Subject: Duke Energy Carolinas, LLC.  
William States Lee III Nuclear Station - Docket Nos. 52-018 and 52-019  
AP1000 Combined License Application for the  
William States Lee III Nuclear Station Units 1 and 2  
Response to Request for Additional Information  
(RAI No. 447)  
Ltr# WLG2008.11-08

**Lee Nuclear Station Response to Request for Additional Information (RAI)**

**RAI Letter No. 035**

**Reference NRC RAI Number(s): RAI 02.03.02-001**

FIGURE 2CC-206  
WIND SPEED FREQUENCY  
(10 M LEVEL)

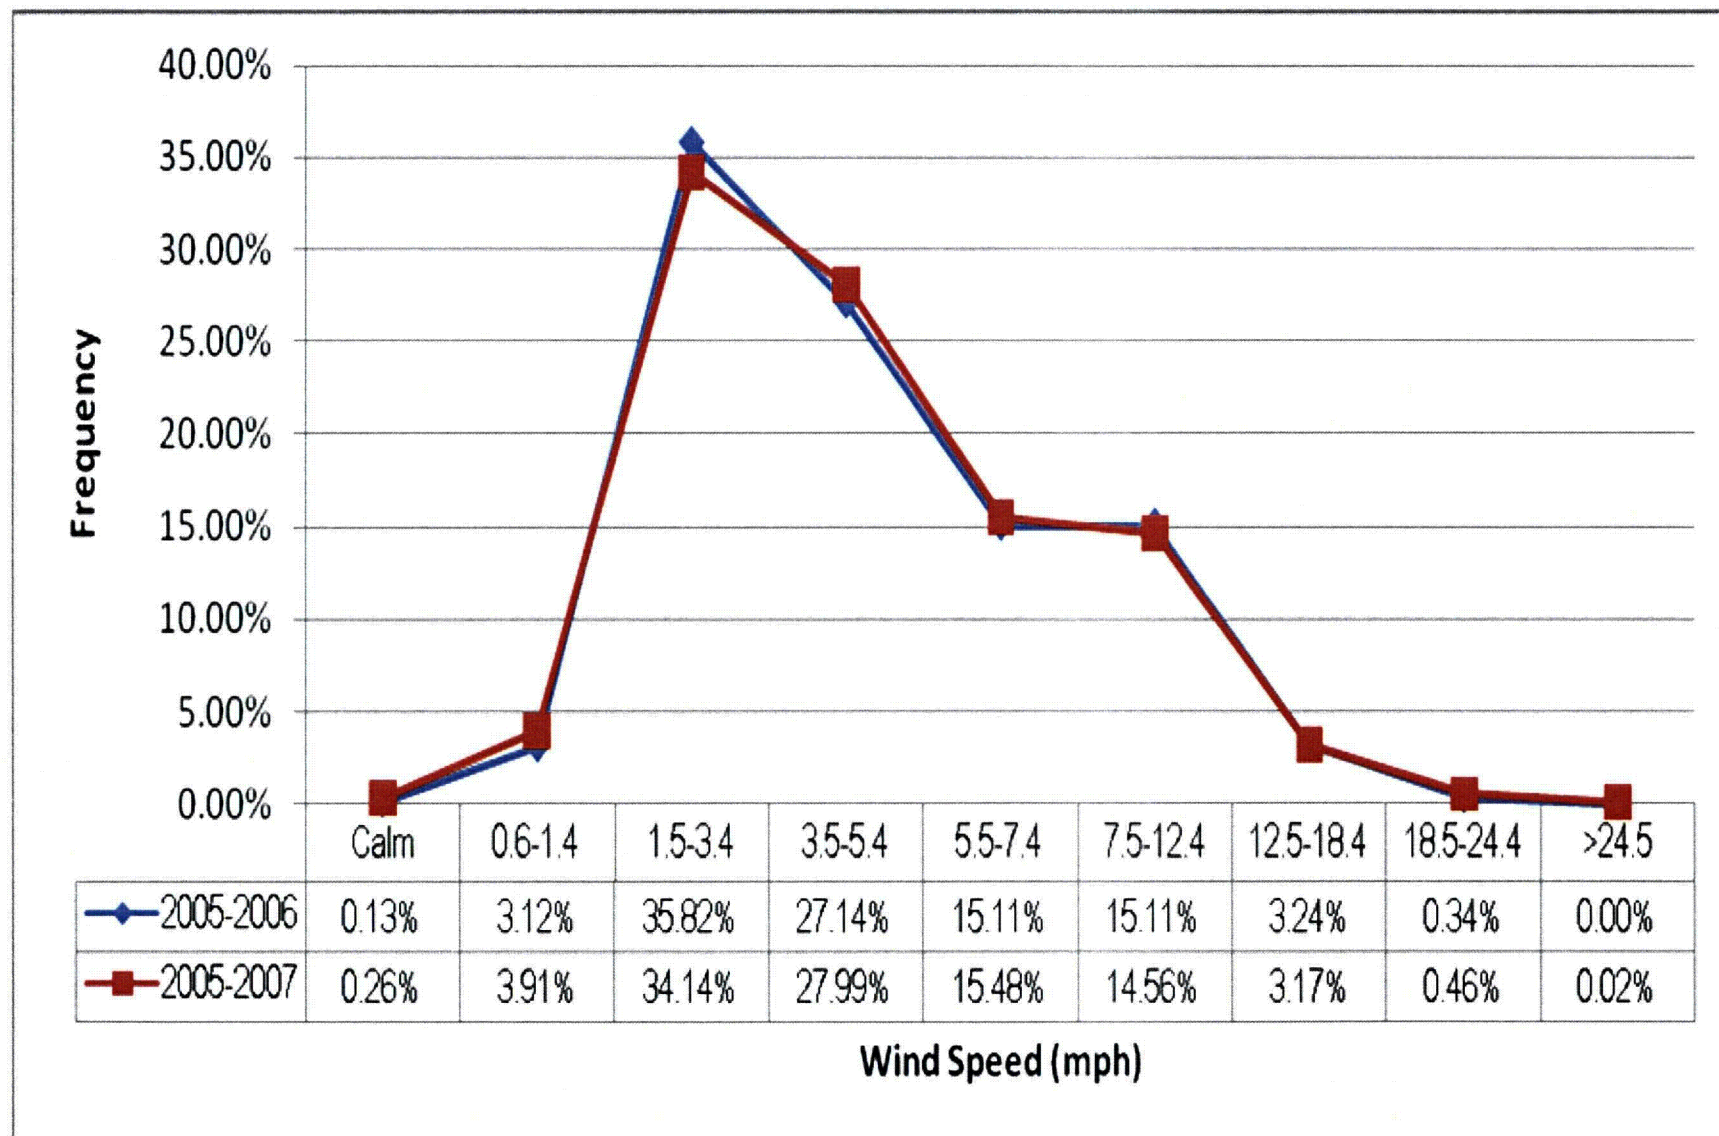
Please revise FSAR Sections 2.3.2.1.2, 2.3.2.1.3, 2.3.2.2, 2.3.2.3, and 2.3.2.3.1 based on at least two years of consecutive onsite meteorological data, as specified in Regulatory Guide 1.23, Revision 1 or justify an alternative method.

The comparison of the wind speed percentage frequency at the lower (10-m) measurement level for the first year and the two-year data set is given in Figure 2CC-206. This comparison shows that the datasets agreed very well and there is no significant difference in the wind speed percentage frequency for either period. The most common wind speed is in the 1.5 through 5.4 mph range.

**FIGURE 1**  
**Stability Class Comparison**

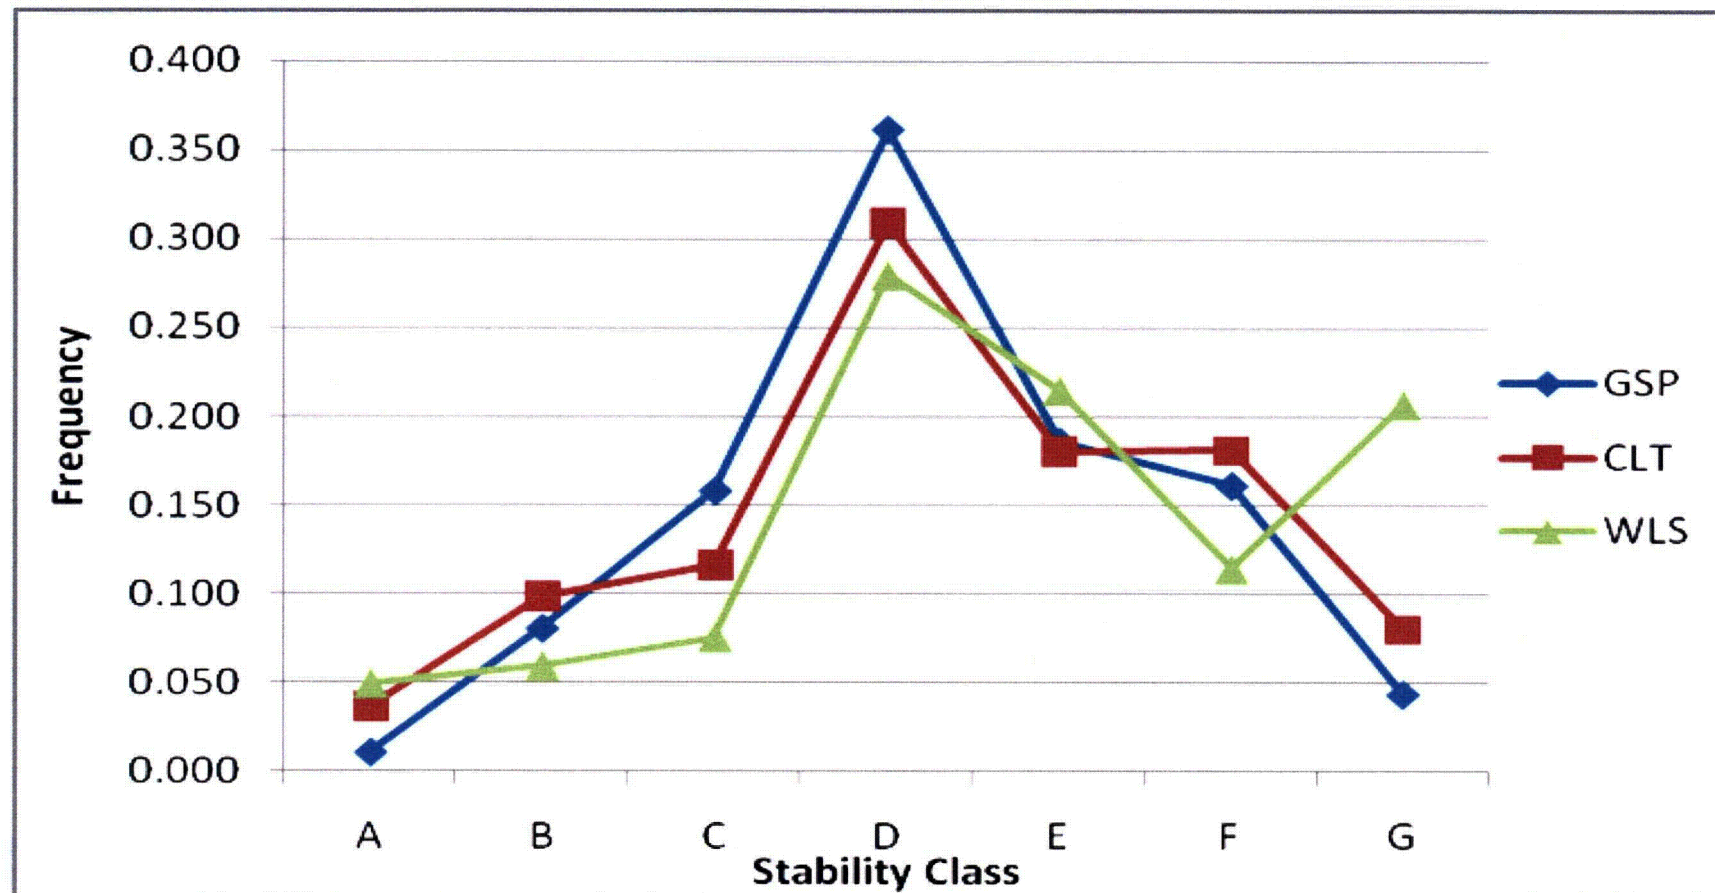
Please provide a copy of the SACTI input files (e.g., PREP.USR, MULT.USR, TABLES.USR, and PAGE.USR) so the staff may conduct a confirmatory analysis. Also, please justify how using NWS data from Charlotte, North Carolina is representative of site conditions given that monthly and annual average wind distributions differ due to site-specific topographical features.

The stability class frequencies for the CLT weather station, the GSP weather station, and Lee Nuclear Station site are compared in Table 1 and Figure 1. Stability class is determined at the NWS sites by the STAR method, which uses wind speed, cloud cover, and ceiling height data in the calculation. The two NWS sites (i.e., Charlotte and Greer) have similar frequency distributions with fewer occurrences of the extreme unstable and stable classes (i.e., A and G stability class) for Greenville and more occurrences of neutral stability (i.e., D stability class). The Lee Nuclear Station stability classes, based on the vertical temperature difference (Delta-T) method, exhibit much more frequently occurring G stability class and stable classes (i.e., E, F, and G) in general with approximately 54 percent occurrence of the stable classes versus 44 percent for Charlotte and 39 percent for Greer. Therefore, the Lee Nuclear Station onsite stability class distribution would tend to produce lower plume rises. The differences between stability class frequencies between the NWS sites and the Lee Nuclear Station site is attributable to the location of the Lee Nuclear Station site in a shallow river valley, as well as the different methods used to determine the stability classes.
